1763 : **Batchbrook Cottage, Catsham**

Variation of Condition Document

The purpose of this document is to establish variations to the conditions in association with the approved application 2023/0360/FUL at Batch Brooke, Mulchelney Road, Baltonsborough, Glastonbury, BA6 8PQ.

Fig 1: Consented Site Plan

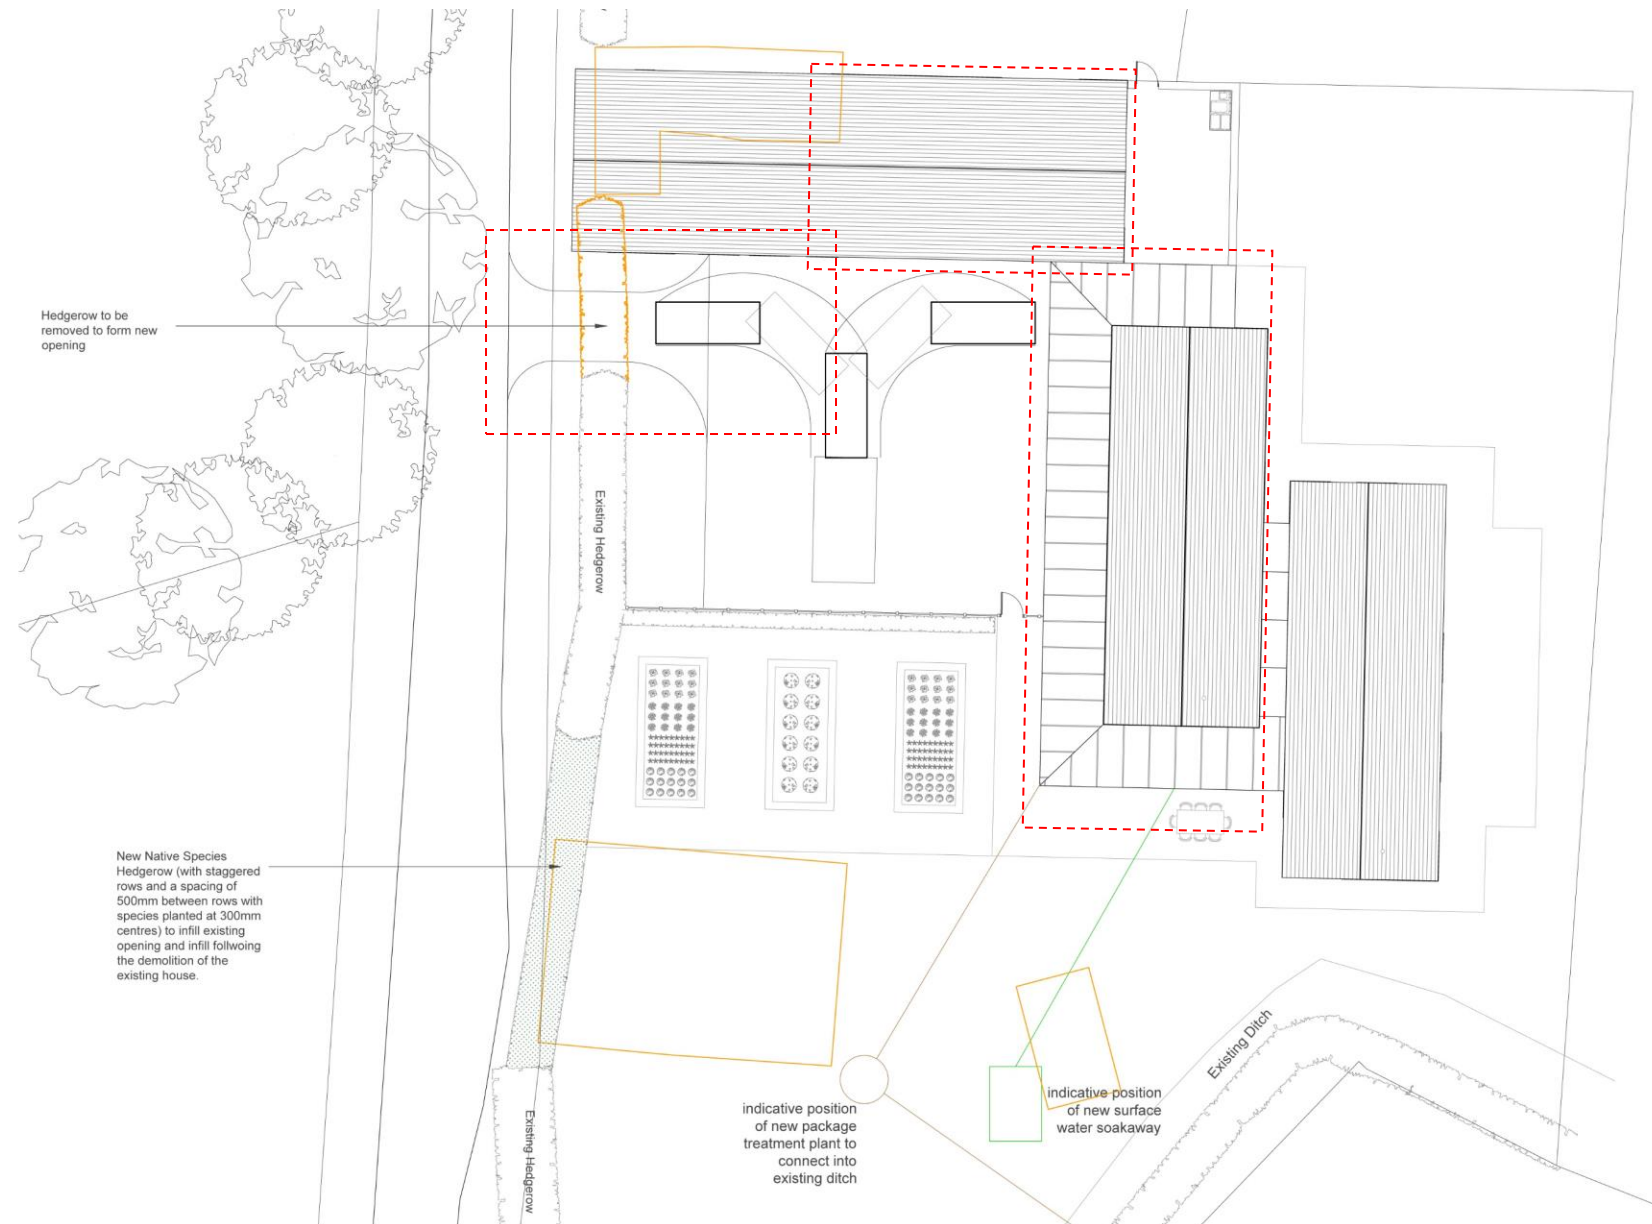
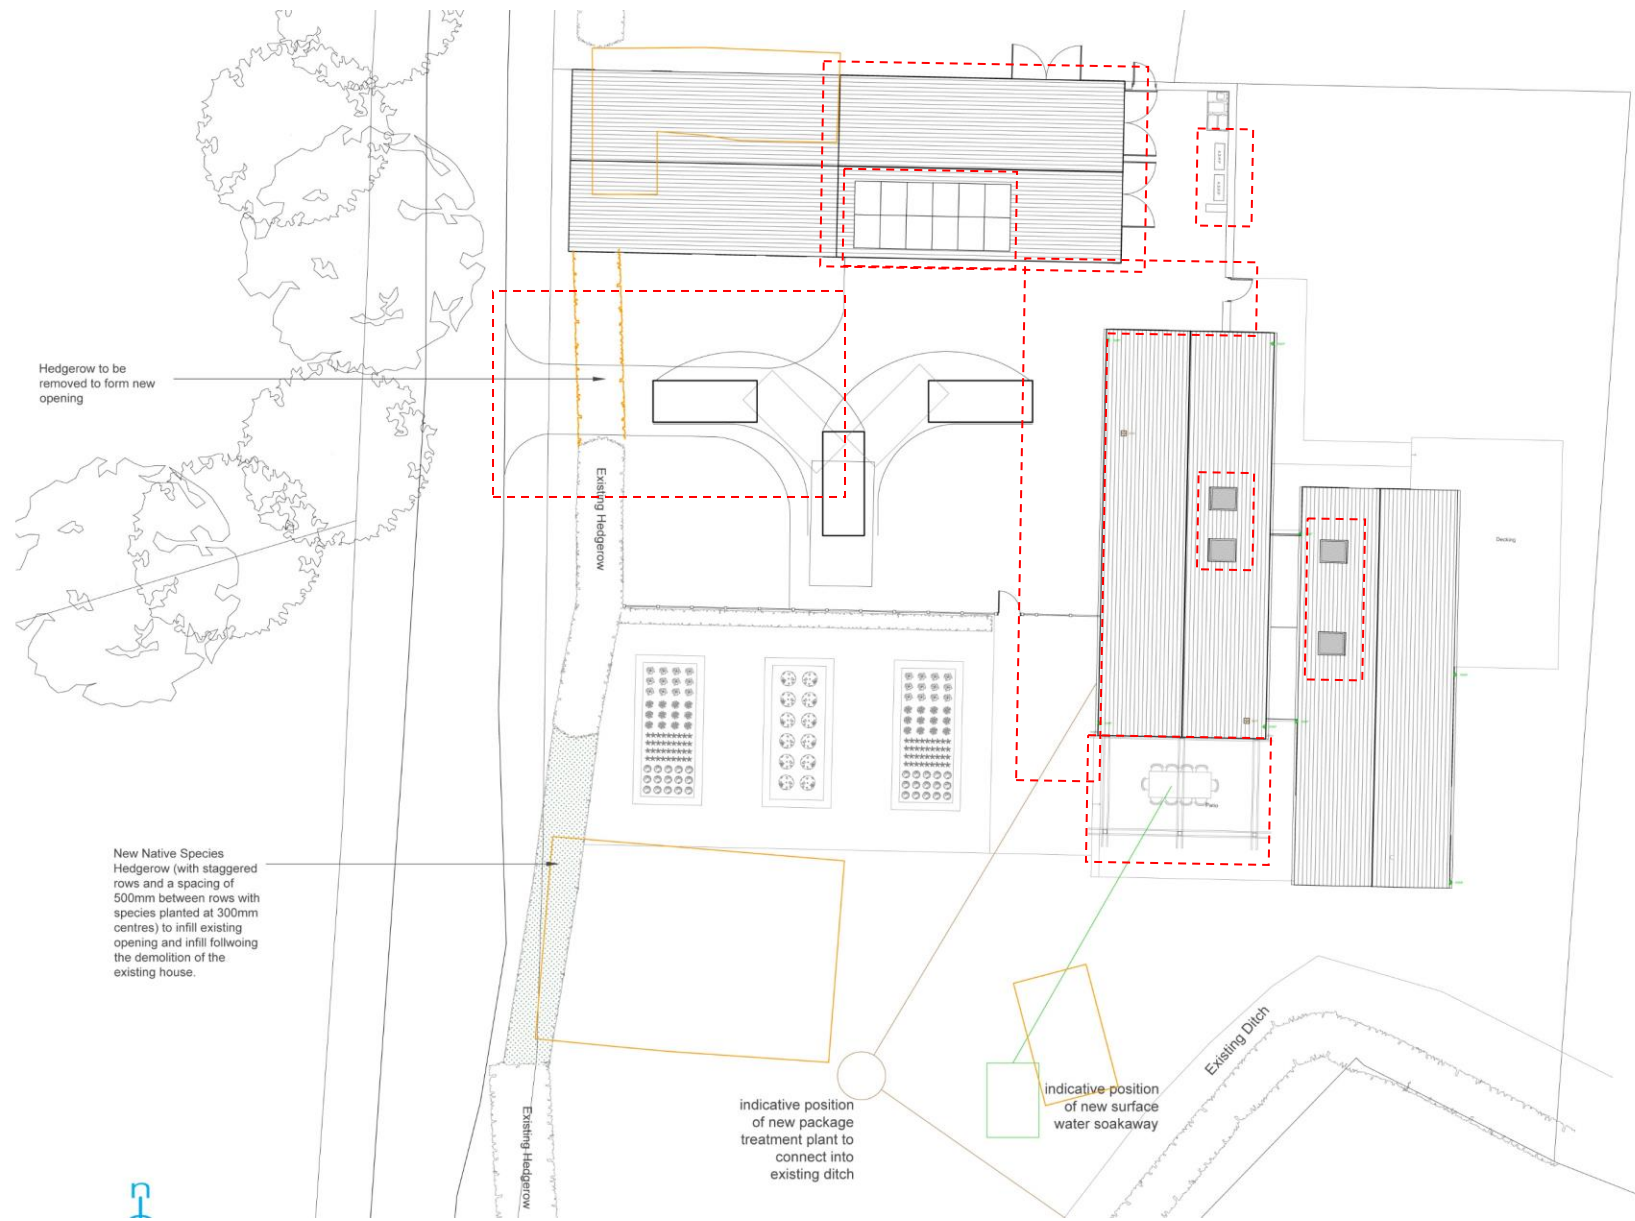
This application seeks to vary the condition on the consented scheme by increasing the height of the carport to incorporate a storage loft, the veranda wrapping around the principle elevation of the two storey element has been removed, and the driveway has been proposed to move central to the parking, which has no adverse affects on the visibility splay (see drawing 1763/007B).

- centralising the access as shown
- introducing PV to the raised roof of the carport
- moving the ASHP to the East of the carport
- removing the veranda
- 2no. rooflights in the two storey element of the dwelling on the east façade
- 2no. Rooflights in the single storey element of the dwelling on the west façade
- Pergola to the south in place of the veranda

Fig 2: Dwelling Floor Plans

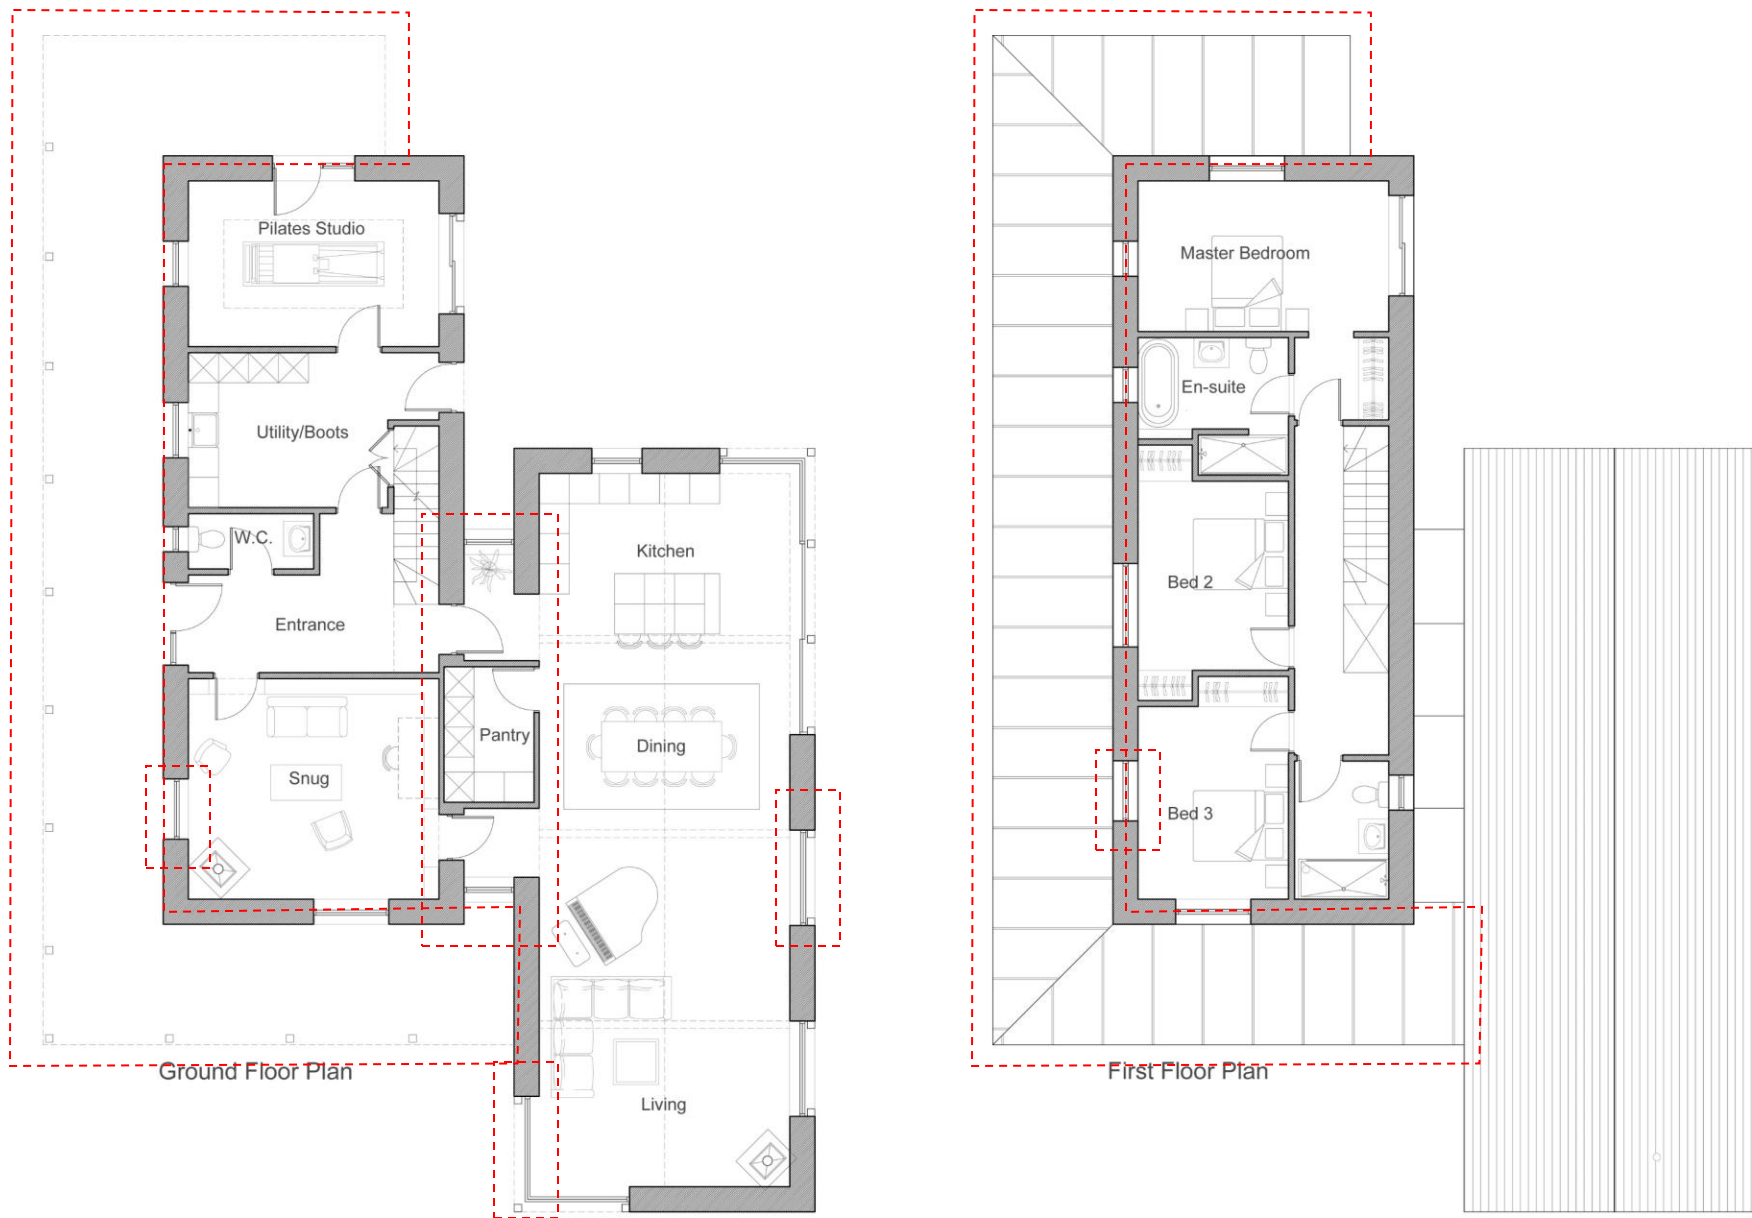
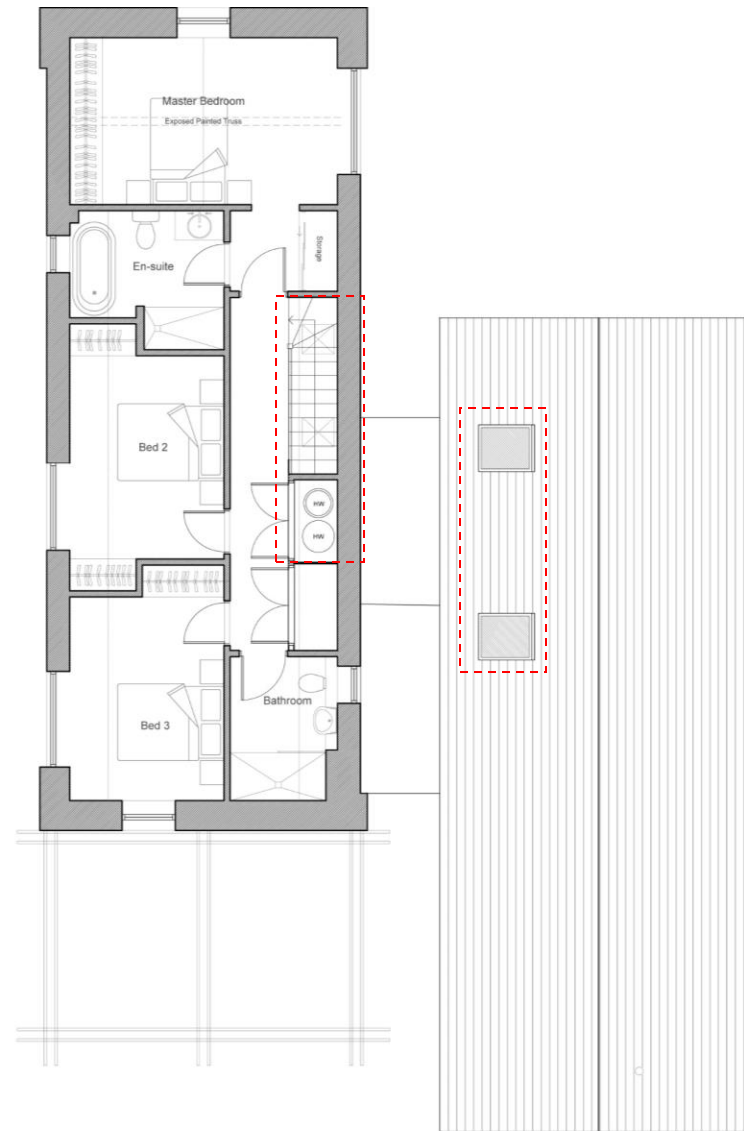
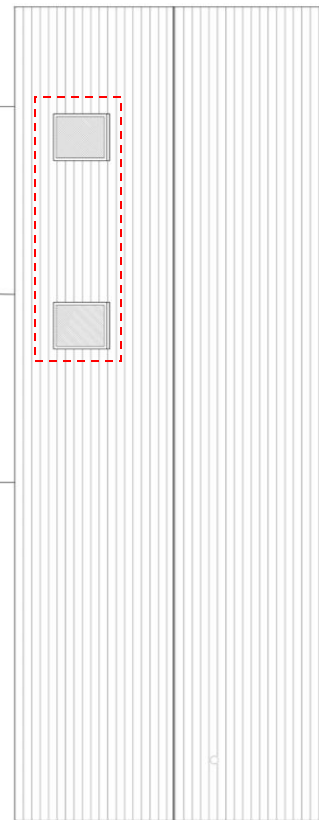
This application seeks to vary the condition on the consented scheme by removing the veranda that wraps around the principle elevation of the two-storey element, alter glazing with the loss of the single pane in the single storey element to the east and the widening of the glazing to the west in the Snug, bedroom 3 and Living and the link.

- removing the veranda
- 2no. rooflights on the landing
- 2no. Rooflights in the kitchen and dining room
- Pergola to the south in place of the veranda
- Front door mirrored in the opening
- Enlarged glazing in the north-east corner of the open plan living space and the loss of the single pane

Fig 3: Consented Ancillary Floor Plans

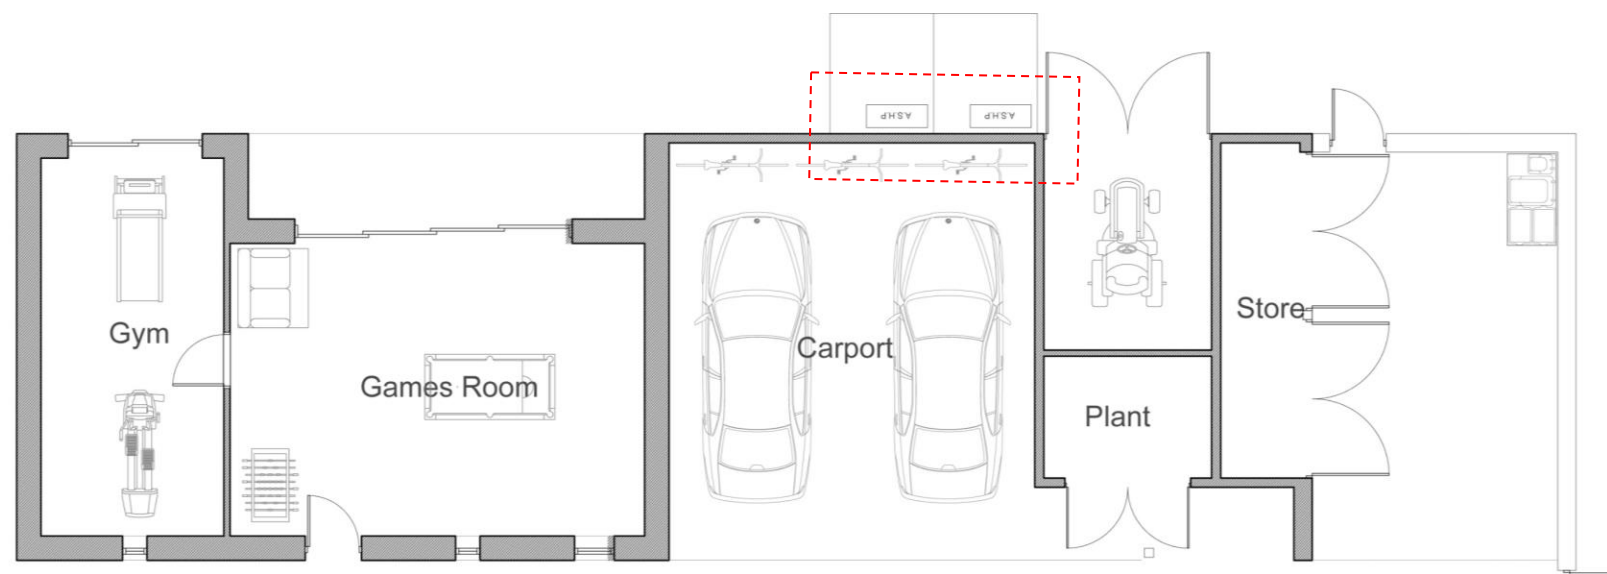
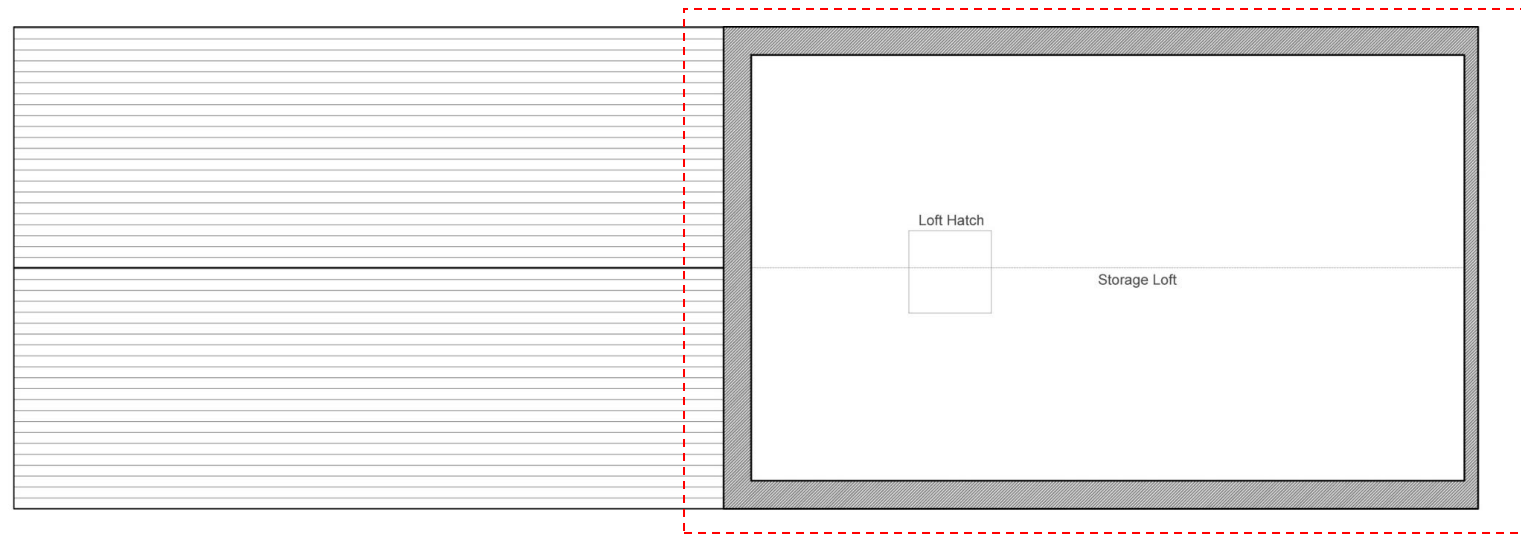
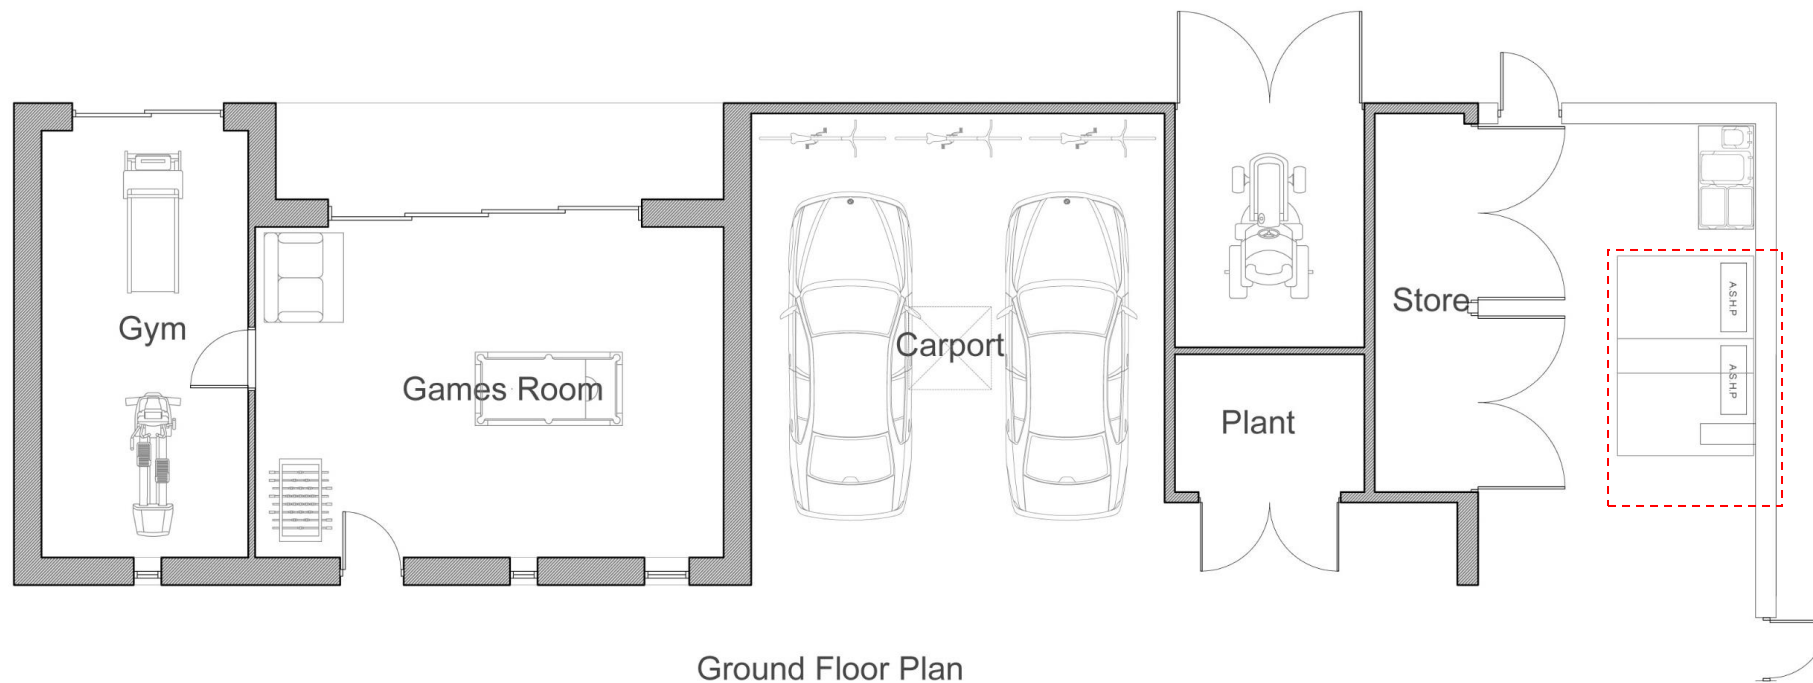
This application seeks to vary the condition on the consented scheme by increasing the height above the carport to include a storage loft and the altered location of the ASHP from the Northern elevation of the carport.

- moving the ASHP to the east
- increasing height of carport to incorporate a storage loft, with access via loft hatch
